**NOTICE OF FINAL  
FINDINGS, CONCLUSIONS, AND DECISION  
OF THE CITY OF PORTLAND HISTORIC LANDMARKS COMMISSION  
ON AN  
APPEALED ADMINISTRATIVE DECISION  
(Type II Process)**

**CASE FILE: LU 14-186226 HR – New Solar Array**  
**LOCATION: 1552 SE Hickory**

The applicant proposes a new 216 square foot solar panel array on the roof to be located on the roof of the existing single dwelling. The solar panels are proposed to be mounted parallel to the east-sloping roof. Also proposed is an energy meter located on the east façade toward the rear of the building.

ARRAY DESIGN -  
ROOF LAYOUT

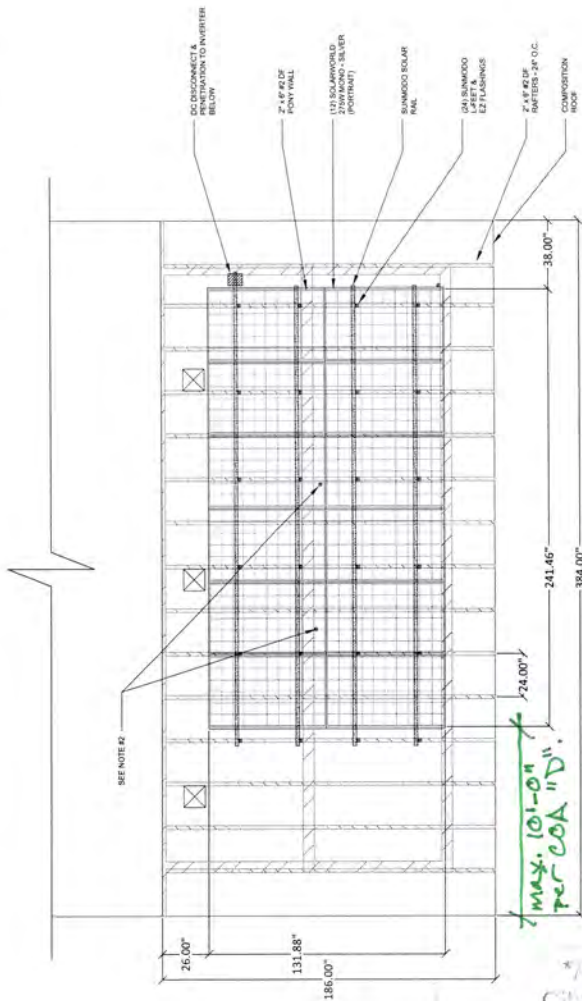
**Findings:** Staff originally noted that the proposed solar array was to have a silver frame to better blend with the gray shingled roof, that the array was to occupy approximately 2/3 of the west roof slope, and be offset from the roof 8 inches. Staff believed that because of the extent of the array and the conditions of the site, the array would be clearly visible, and not inconspicuous, from the street. The Commission noted that because these guidelines specifically mention solar equipment, it suggests that the incorporation of roof-mounted solar equipment is more acceptable in this historic district rather than other historic districts with different approval criteria.

As noted above, the majority of the Commission believed that the proposed array was relatively inconspicuous, due to its location on the rear 2/3 of a single slope of the roof, and suggested conditions of approval to ensure additional inconspicuousness and reinforce aspects of the proposal as presented. These conditions require that the panels be composed of black cells on a black backing, that the array be parallel to the roof slope and be offset no more than 5 inches above the roof as measured from the top of the roof shingles to the top of the panel, that the array be located at least 10 feet back from the front edge of the roof, and that the system be removable.

- A. As part of the building permit application submittal, each of the 4 required site plans and any additional drawings must reflect the information and design approved by this land use review as indicated in Exhibits C-1 through C-7. The sheets on which this information appears must be labeled, "Proposal and design as approved in Case File # LU 14-186266 HR. No field changes allowed."
- B. The solar cells shall be black, on a black background.
- C. The array shall be parallel to the roof slope and offset no more than 5 inches from the top of the roof shingles to the top of the panel.
- D. The array shall be installed at least 10 feet back from the front edge of the roof and the system must be removable.
